Draft Final Engineering Evaluation/Cost Analysis Former Camp Hero Montauk, New York

Subject: Contract DACA87-00-D-0038, Delivery Order 0002
revised Draft Final EE/CA Report Deliverable for
Former Camp Hero, Montauk, New York

FORMER CAMP HERO

Page
SECTION 11 REFERENCES.....	11-1
APPENDIX A – STATEMENT OF WORK (SOW)	
APPENDIX B – ANOMALY DIG SHEETS	
APPENDIX C – SCRAP CERTIFICATION FOR DISPOSAL	
APPENDIX D – INSTITUTIONAL ANALYSIS REPORT	
APPENDIX E - RESPONSE TO COMMENTS

**FIGURE 1.1
ORGANIZATIONAL STRUCTURE FOR
FORMER CAMP HERO EE/CA**

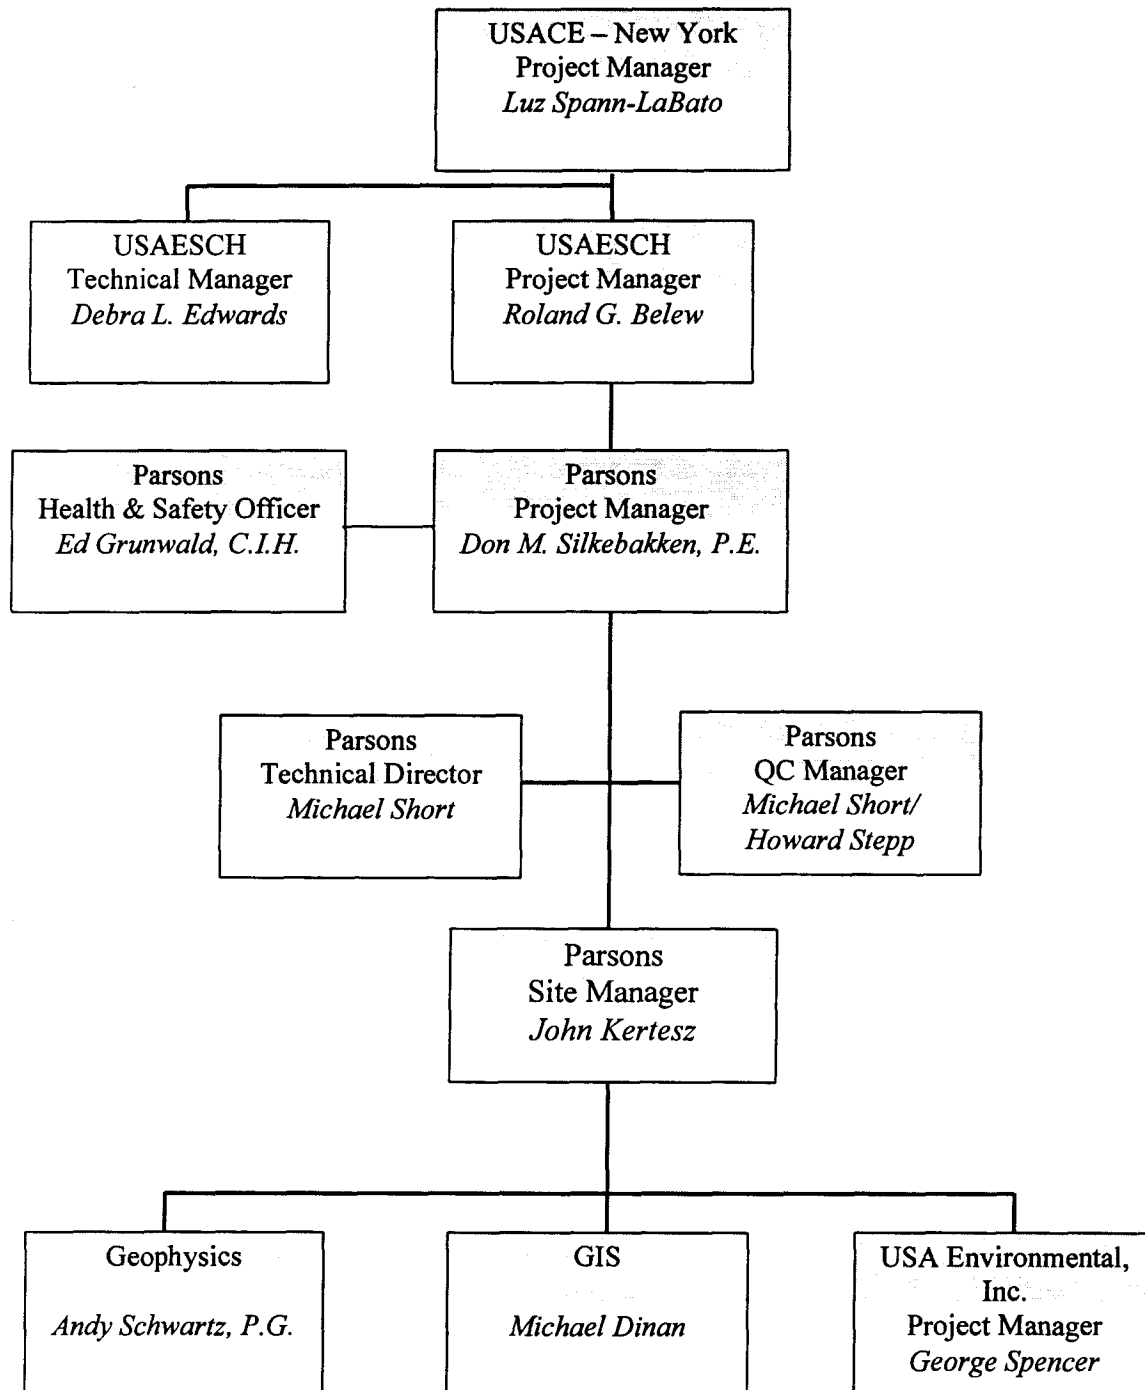
ITEM	DRAWING NO. OR REFERENCE	COMMENT	ACTION
1	Table of Contents- Page iv	Section 7.5.4.3 is titled "Cost1" - Please correct typo.	A - The text was modified in accordance with the comment.
3	Page 1-4; Figure 1.1	Connect the Parsons Health & Safety Officer to the rest of the chart.	A - Figure 1.1 has been modified in accordance with the comment.
4	Page 2-2; Para. 2.3.1	Place a comma after the word campaigns to make the sentence read easier.	A - The text was modified in accordance with the comment.
5	Page 3-31; Figure 3.10	There is no reference to this Figure. Please include reference in text.	A - Reference to this figure has been added to the Section 3 document text.
6	Page 2-9; Fig. 2.2	Area L is not identified on this map. Please revise to include an Area L marker on the map.	A - Area L represents the water training ranges and a reference has been added to the figure.
8	Page 4-3; Para 4.2.2.4	Please remove the additional period (.) from the end of the paragraph.	A - The text was modified in accordance with the comment.

Figure 2.2

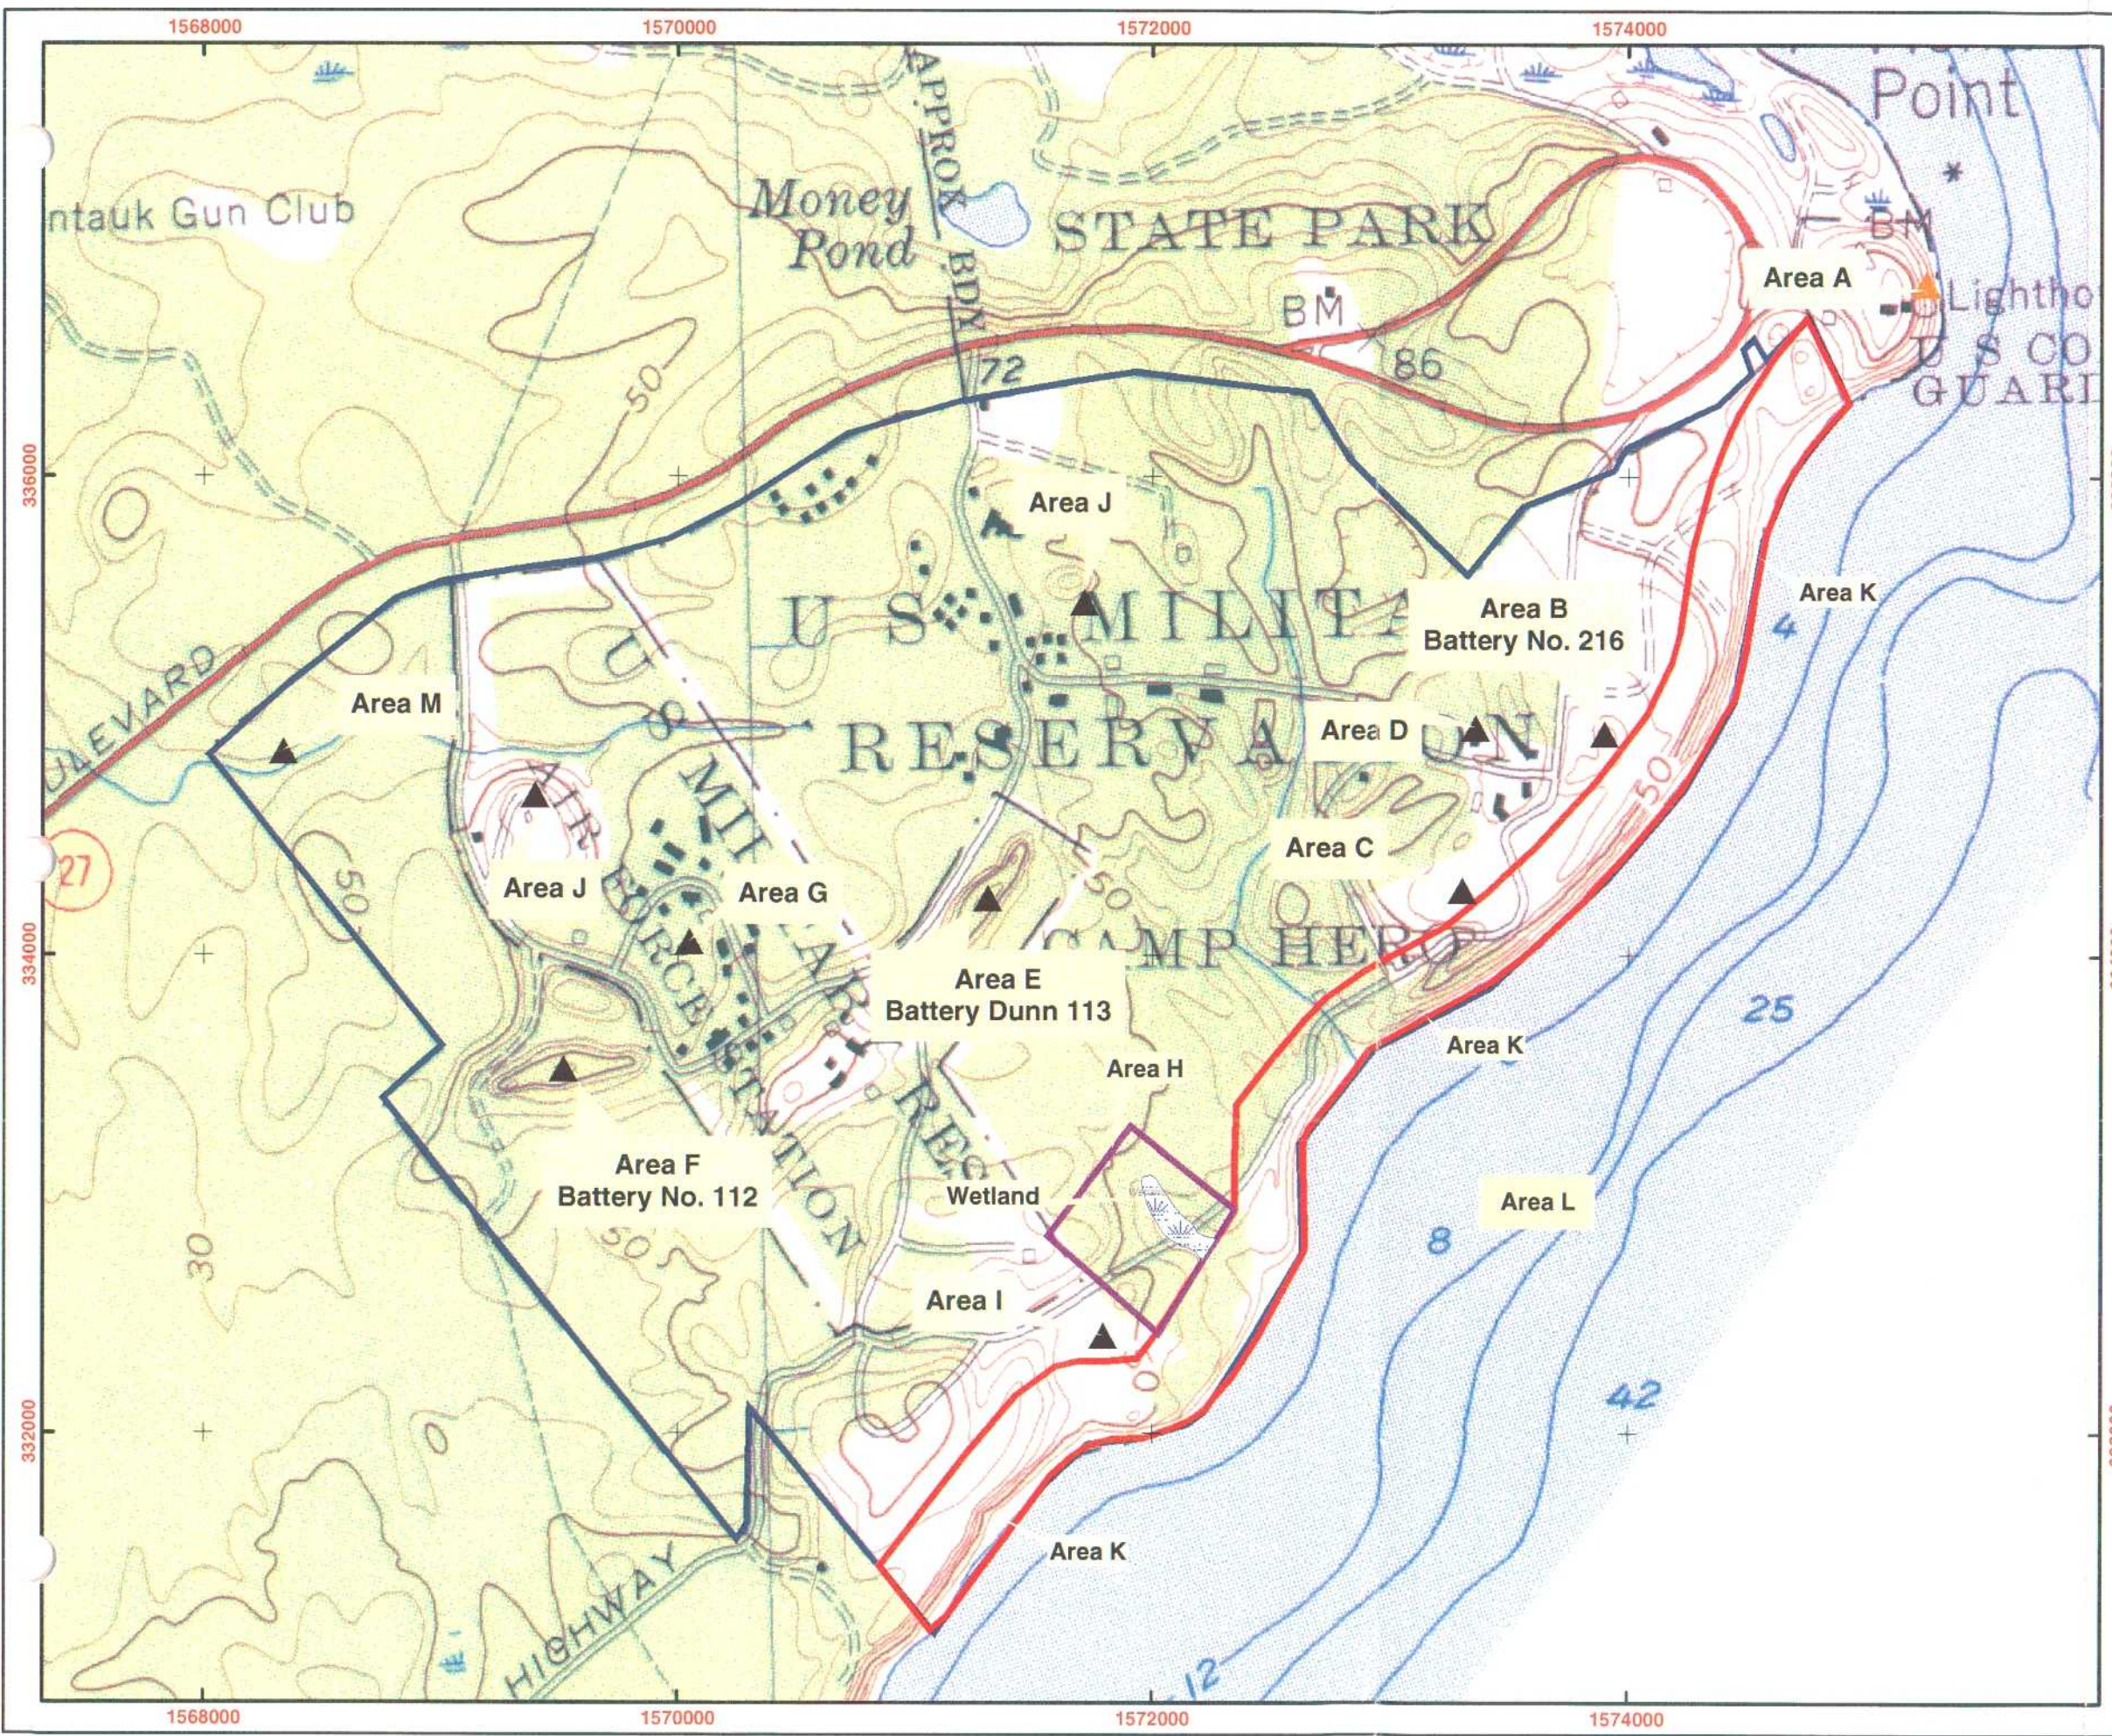
2.	Page 2-9, Figure 2.2	The scale is stated wrong in the title block. The bar scale is correct at 1" = 1000', however this would translate to 1:12,000. Change the title block.	A – Figure revised as requested.

Figure 3.5

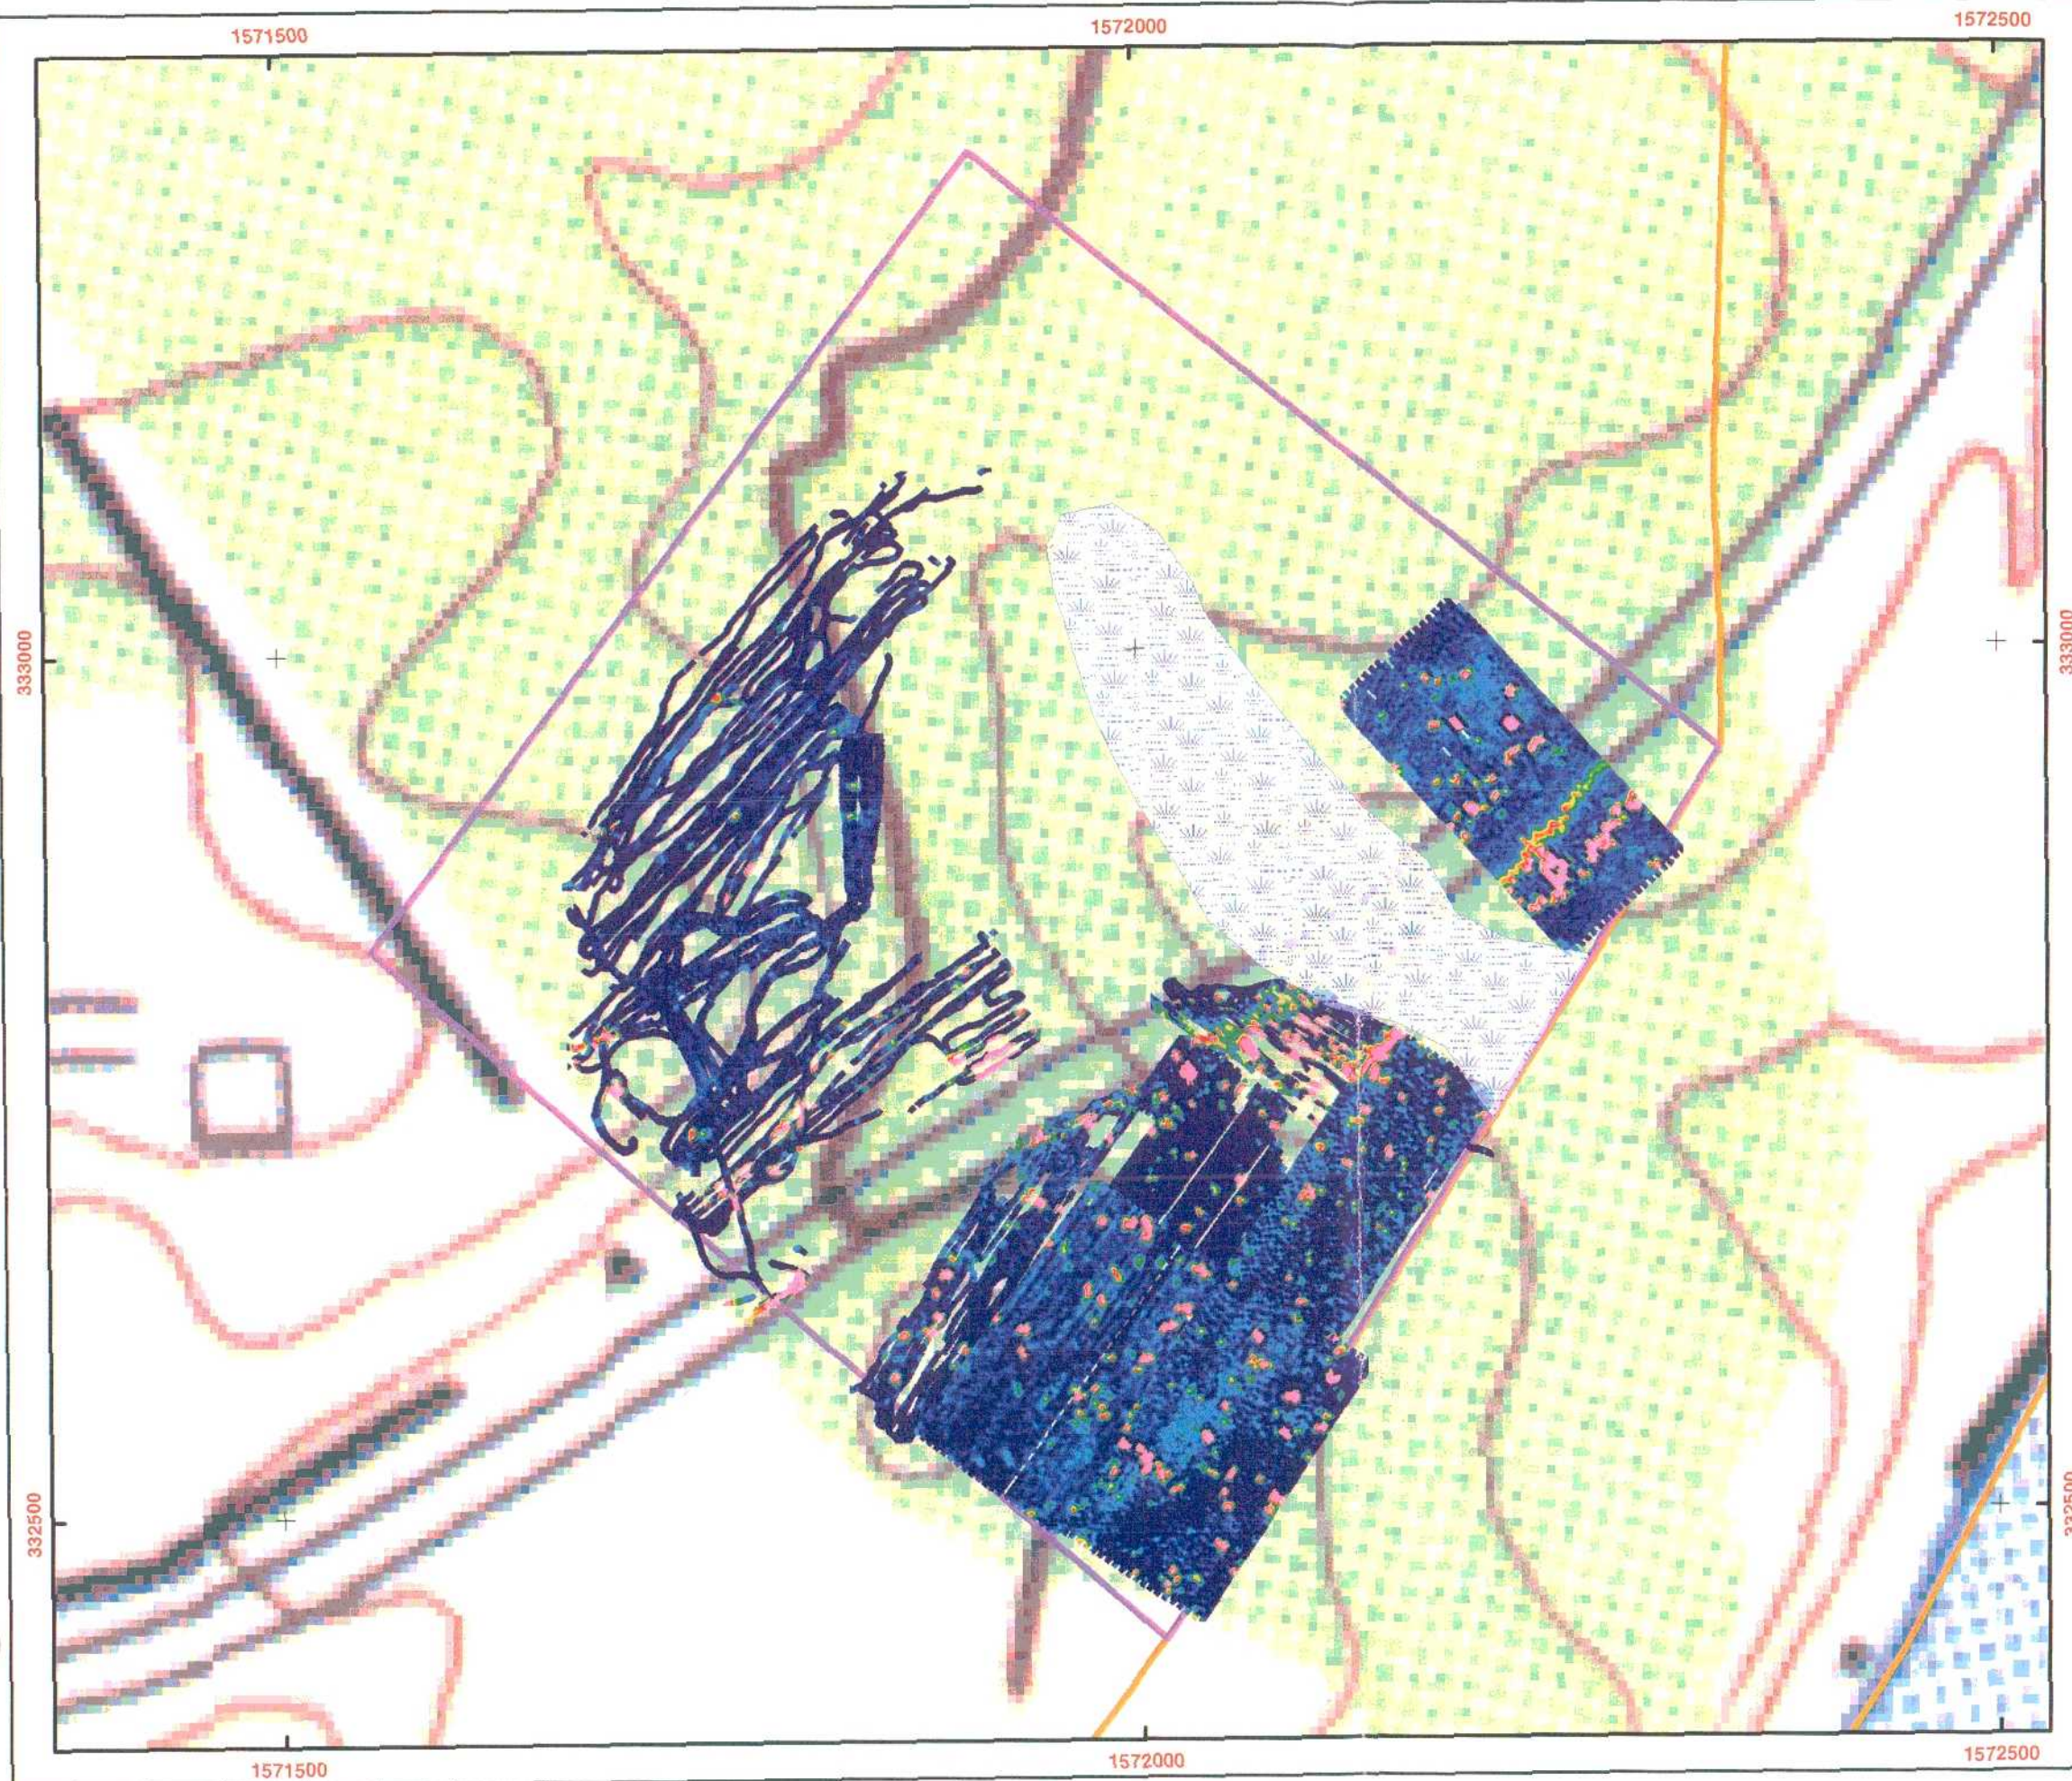
3. Clarify your statement and fig 3.5 that state 6 out of 8 acres of area H was "surveyed". Clearly 6 acres was not mapped. You visually surveyed 6 acres but mapped less. Please clarify this. You do not need to discuss your visual survey, only what you mapped.
